Batch 2: the dormitory's door at the stair head

The Architect, 13 October 2026, for Godric. The ledger's line 5 (docs/architect/changes.md); the castle model, version 16; Godric's 1 on dormitory-sign-door-1013, already ruled. Red: what changes.

Plan at the floor, north up (1:100): the screen and its door (line 5)

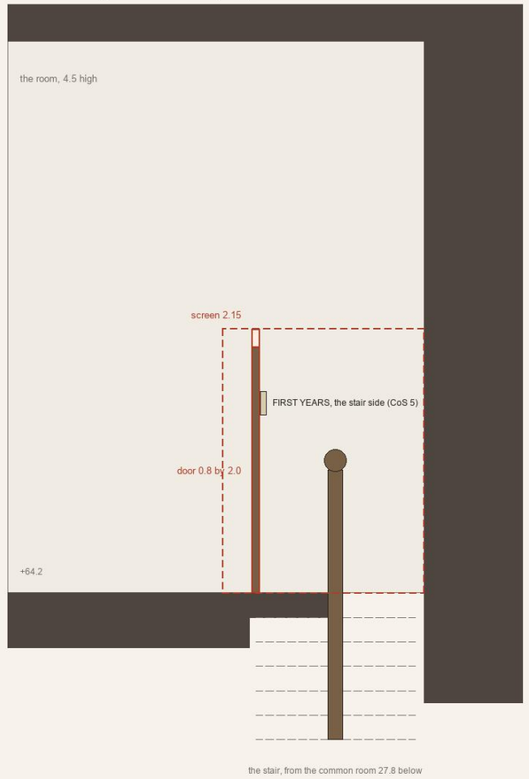
A panelled screen 2.15 m high round the newel on the kerb's line, 0.92 m from its centre, three quarters of the circle; behind the newel it meets the tower's wall, since the newel stands 0.73 m inside it. Its door, 0.8 by 2.0, in the kerb's gap across its 1.30 m chord, 0.65 m from the newel toward the room, its threshold on the stair's top step, opening into the room; jambs 0.25 m each side; the year's sign on its stair side (FIRST YEARS, then SECOND YEARS, CoS 5). The bed at 53 stays 0.19 m clear of its hangings (the Dormitory's measure; 0.28 m to its 1.0 m frame on this plan). The stair head is no longer open. Placed, model 16 (dorm-stair-screen, dorm-door).
